**[Docket No. FAA-2011-1231; Directorate Identifier 2011-NM-088-AD; Amendment 39-17418; AD 2013-08-01]**

**Airworthiness Directives; The Boeing Company Airplanes**

**ACTION:** Final rule.

**SUMMARY:** We are adopting a new airworthiness directive (AD) for certain The Boeing Company Model 737-600, -700, -700C, -800, -900, and -900ER series airplanes. This AD was prompted by reports of damaged fire seals on the forward edge of the thrust reverser. This AD requires inspecting to detect damage to the upper fire seals on the forward edge of the thrust reverser, where the fire seal contacts the 12-o'clock engine strut, and for correct stiffness and vent holes, and doing corrective actions if necessary; and installing a bracket for the fire seal. We are issuing this AD to detect and correct damage to the fire seals, which could allow airflow into the engine fire zone and could degrade the ability to extinguish an engine fire.

Figure 1, Fastener Removal of the Retainer Support on the Left Thrust Reverser Half

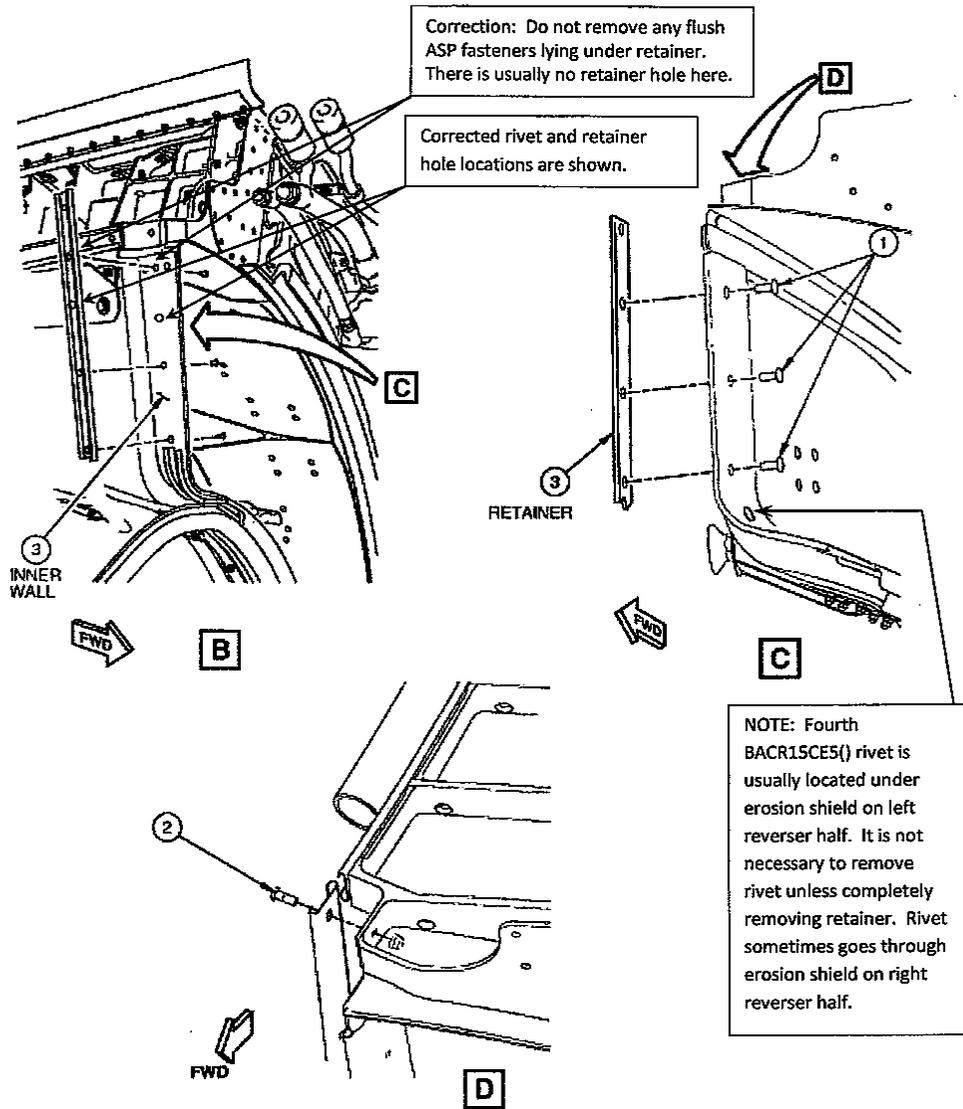
(2) Figures 1 and 3 of this AD, titled “Fastener Removal of the Retainer Support on the Left (Right) Thrust Reverser Half,” have View B showing the top fastener in the center of three adjustable sustained preload (ASP) fasteners. That top fastener does not require removal in order to remove the retainer. The figures in this AD point to the correct information for those fasteners.

Figure 2, Installation of the New Bracket behind the Retainer Support on the Left Thrust Reverser Half

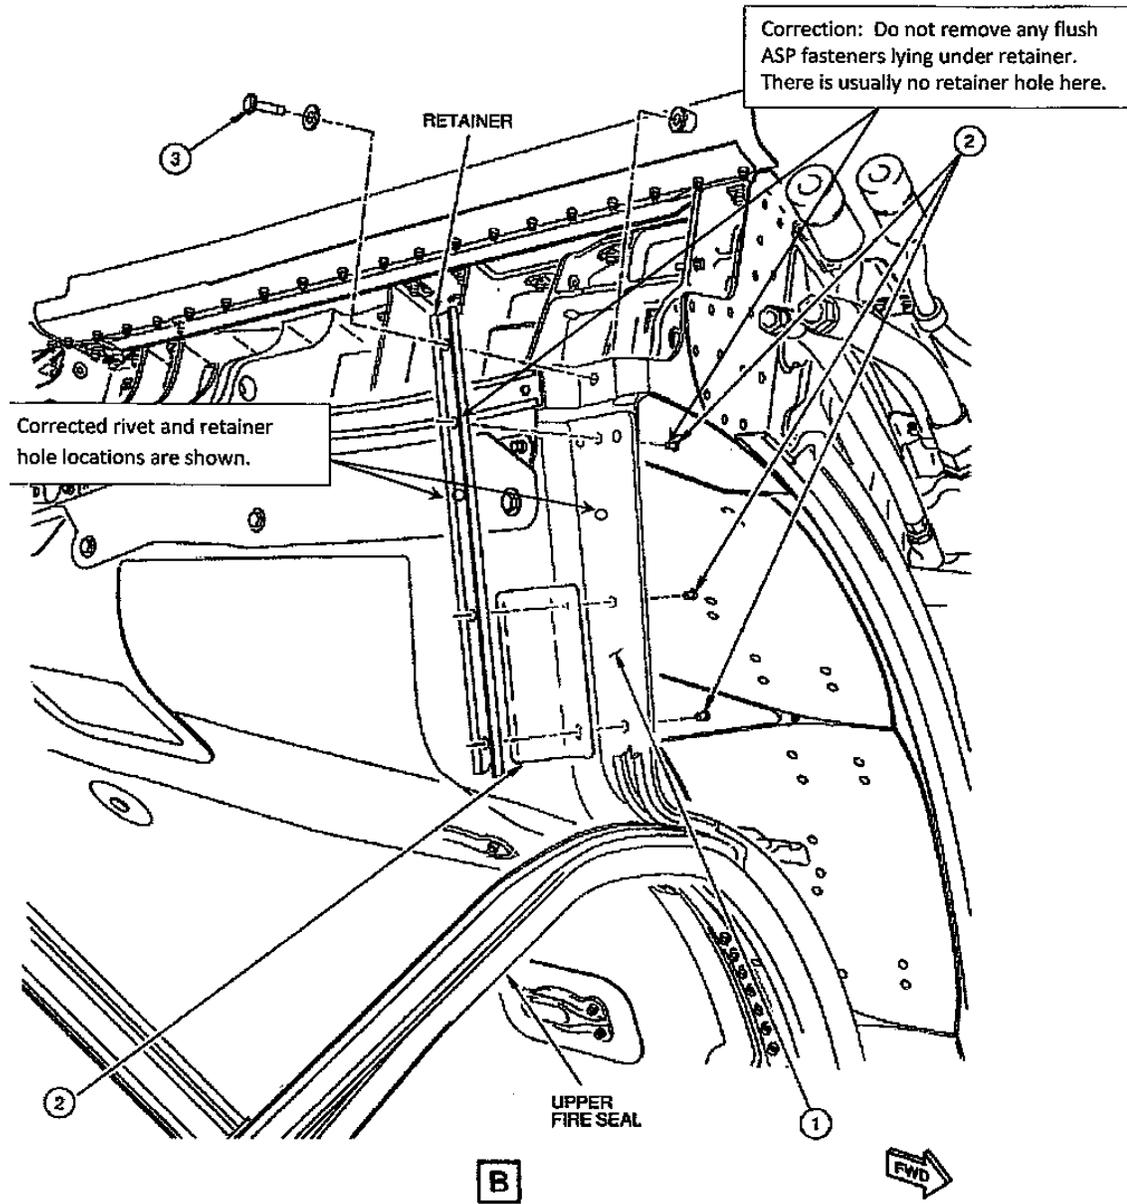
(3) Figures 2 and 4 of this AD, titled “Installation of the New Bracket behind the Retainer Support on the Left (Right) Thrust Reverser Half,” have View B showing the

top rivet hole. That rivet hole is actually below the row of three ASP fasteners. The figures in this AD point to the correct information for those rivet holes.
